1 **NOTICE OF RULE MAKING PROCEEDINGS AND PUBLIC HEARING**

2
3 **NORTH CAROLINA BUILDING CODE COUNCIL**

24
25 **Statement of Subject Matter:**

**FIGURE R4603.6(b)
 TOP MOUNTED GIRDER**

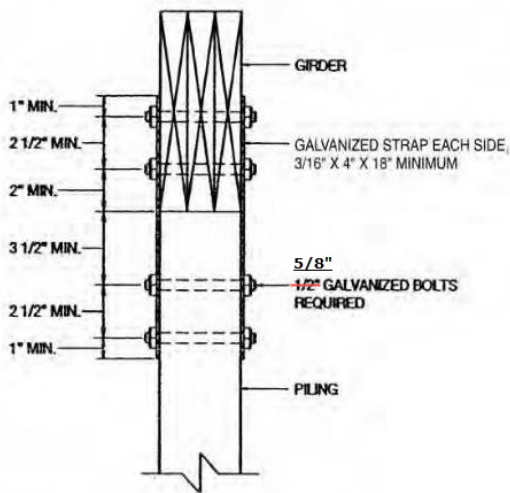
1 **3. Request by Randall Shackelford, P.E., representing Simpson Strong-Tie Company, to amend the**
 2 **2018 NC Residential Code, Section R4603.6 as follows:**

5 Beams and girders shall fully bear on pilings and butt joints shall occur over pilings. If Sills, beams or
 6 girders are shall be attached to the piling a minimum of two 5/8 inch (16 mm) galvanized steel bolts per
 7 beam member shall be through bolted using either bolts or screws at each piling connection in accordance
 8 with Table R4603.6 and Figure R45603.6 (a). When the piling is notched so that the cross-section is
 9 reduced below 50 percent or the girder is is top bearing, sills, beams or girders shall be attached using 3/16
 10 × 4 × 18-inch (5 × 102 × 467 mm) hot dip galvanized straps, one each side, bolted with two 5/8 inch (15.9
 11 mm) galvanized through bolts fastened top and bottom in accordance with either bolts or screws in
 12 accordance with Table R4603.6 and Figure R4603.6(b) and Figure R45603.6(c). Where butt joints occur
 13 over the piling and screws are used, there shall be two straps on each side of the piling, having a minimum

14 size of 3/16 by 2 by 18 inches (5 × 51 × 467 mm), with four self-drilling screws as described in each end.

1 shall be provided at all exterior pile lines. Where the perimeter lines of X-bracing exceed 40 feet (12 192
 2 mm), an additional line of X-bracing shall be provided near the center of the building. See Figure
 3 R4603.6(e). X-bracing shall be with 2 × 10s through bolted with two 3/4-inch (19.1 mm) bolts at each end.
 4 The code official is permitted to accept alternate bracing designs if they bear the seal of a registered design
 5 professional.
 6
 7 Revise Figures as follows:

12 **Reason Given** – The purpose of this amendment is to allow new technology self-drilling fasteners in
 13 addition to through bolts.

**FIGURE R4603.6(c)
 PILING NOTCHED MORE THAN 50%**

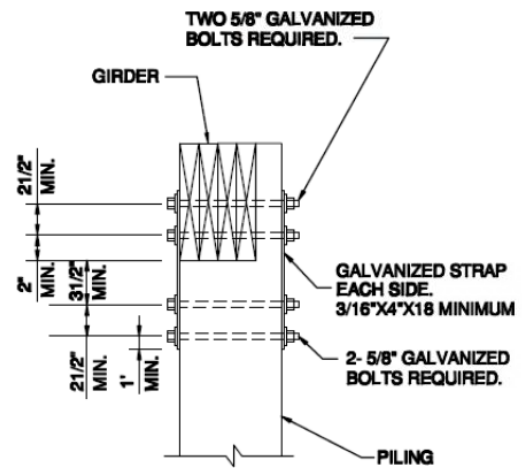
17
 18 1. Where piling is notched over 50%, use strap as required in Section 4603.6. Install the specified number
 19 of bolts or screws in each end of the strap.

15
16
17
18
19
20
21
22
23
24
25 **Figure 410.2 Exception Closet Storage Space Exception**

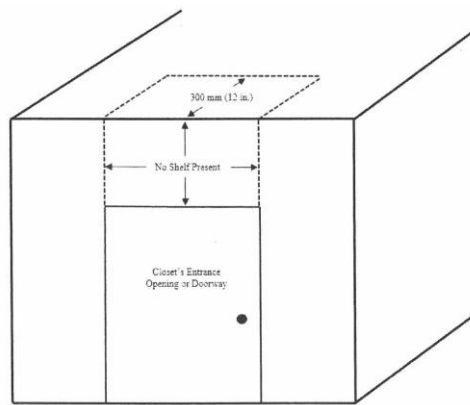
1 **Closet Storage Space.** The volume bounded by the sides and back closet walls and planes extending from
2 the closet floor vertically to a height of 1.8 m (6 ft) or to the highest clothes-hanging rod and parallel to the
3 walls at a horizontal distance of 600 mm (24 in.) from the sides and back of the closet walls, respectively,
4 and continuing vertically to the closet ceiling parallel to the walls at a horizontal distance of 300 mm (12
5 in.) or the width of the shelf, whichever is greater; for a closet that permits access to both sides of a hanging
6 rod, this space includes the volume below the highest rod extending 300 mm (12 in.) on either side of the
7 rod on a plane horizontal to the floor extending the entire length of the rod. See Figure 410.2.

10 Where a shelf is not present in the area of wall above the closet's entrance opening or doorway extending
11 from the top of such opening or doorway vertically to the ceiling, including the area of ceiling extending
12 perpendicular from the area of wall directly above the closet's entrance opening or doorway to a
13 horizontal distance of 300 mm (12 in.) shall not be defined as closet storage space. See Figure 410.2

30 **Reason Given** – The purpose of this amendment is to allow a lighting fixture above the door in a closet.
